CITY OF CHELSEA
PLANNING COMMISSION AGENDA
FEBRUARY 15, 2011, 7:00 P.M.
WASHINGTON STREET EDUCATION CENTER, BOARD ROOM
500 WASHINGTON ST., CHELSEA, MI

**PLANNING COMMISSION MINUTES
FEBRUARY 15, 2011, 7:00 P.M.
WASHINGTON STREET EDUCATION CENTER, BOARD ROOM
500 WASHINGTON ST., CHELSEA, MI**

TO: City of Chelsea Planning Commission
FROM: Carl V. Schmolt, Jr.
Professional Community Planner
DATE: January 13, 2011
Revised February 10, 2011
RE: Police Station/Parking Lot Site Plan
16 sheets, dated February 1, 2011

TO: James Drolett, Planning and Zoning Administrator
FROM: Christine Linfield, City Engineer
SUBJECT: Auto Zone - Planning Commission Preliminary Site Plan Report
DATE: 02/09/11
CC:

Professional Engineering Assoc. (C/Wes Perle)
 ↑ N
 1" = 20' (8.5 x 11")
 2/9/2011
 AutoZone Chelsea

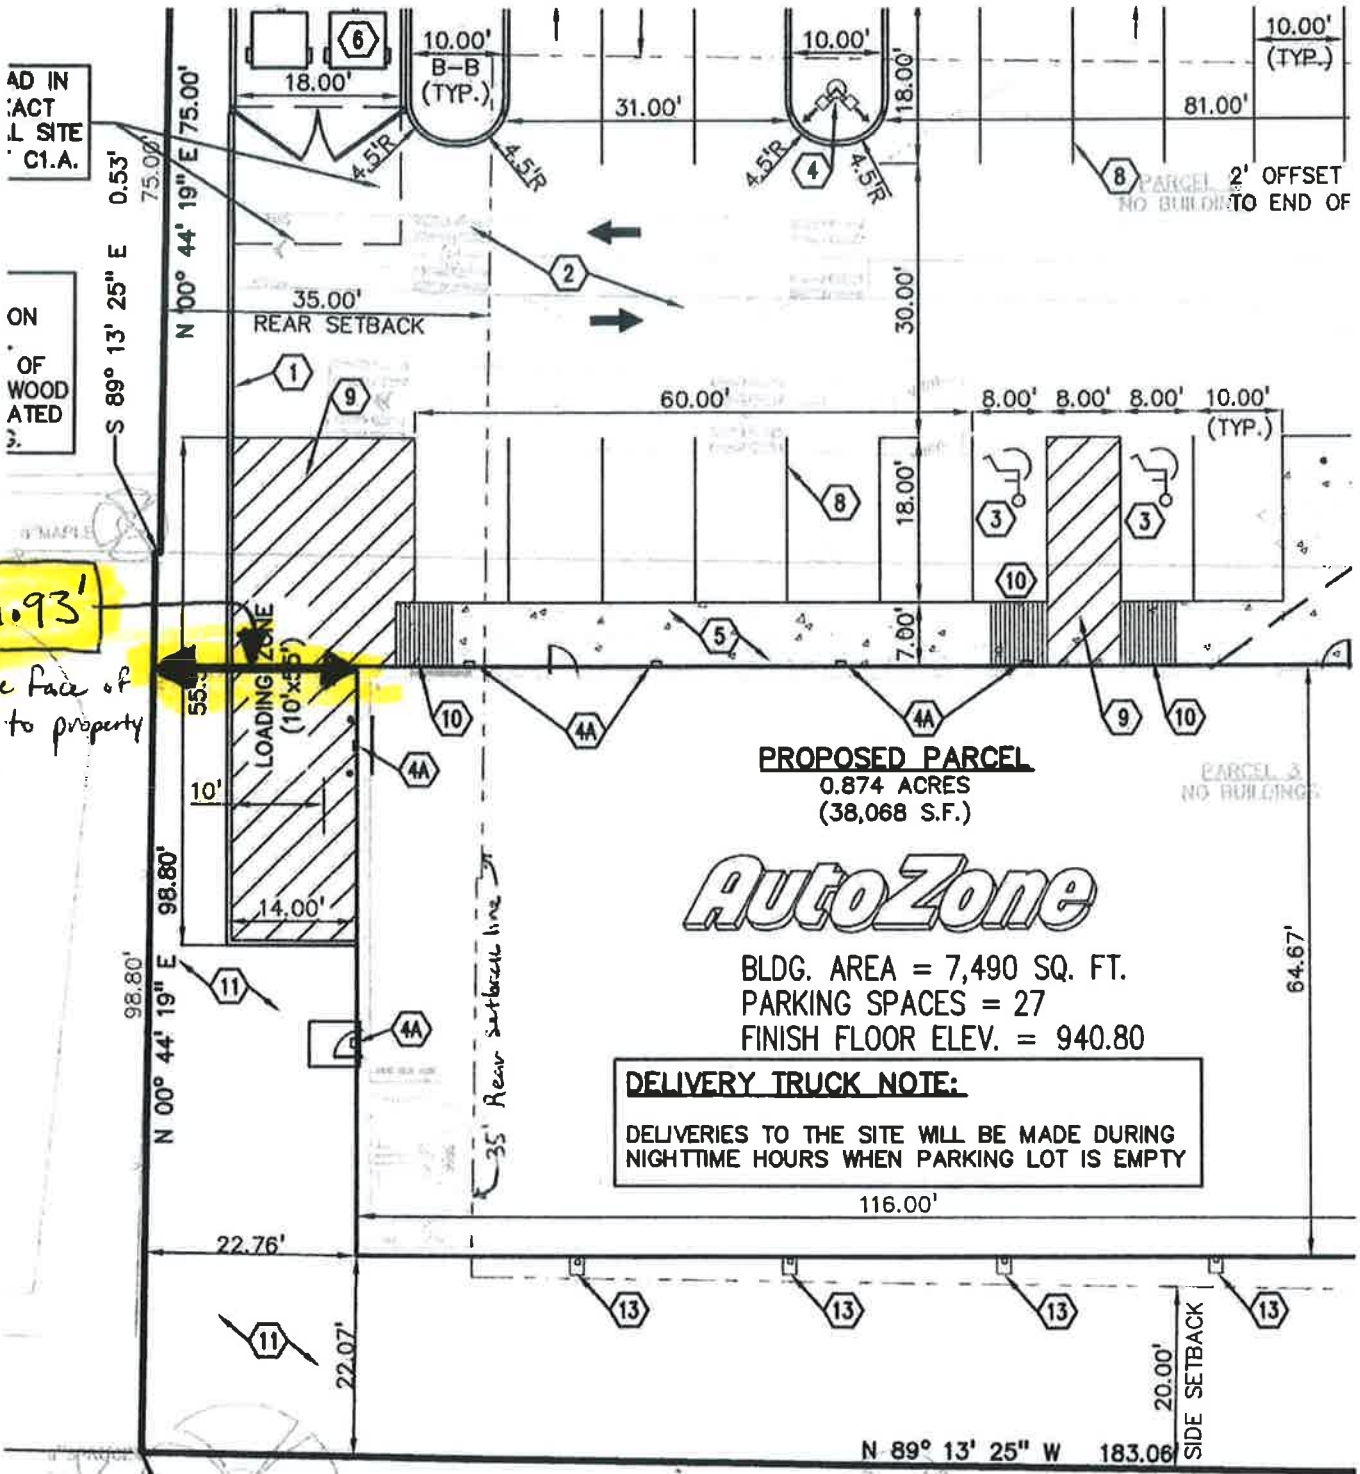
We would like to add that the neighboring parcels to the rear of the site include an existing detention basin directly adjacent, and a cemetery next to the basin. Additionally, landscaping has been added within the rear setback encroachment area.

21.93'
(outside face of
wall to property
e)
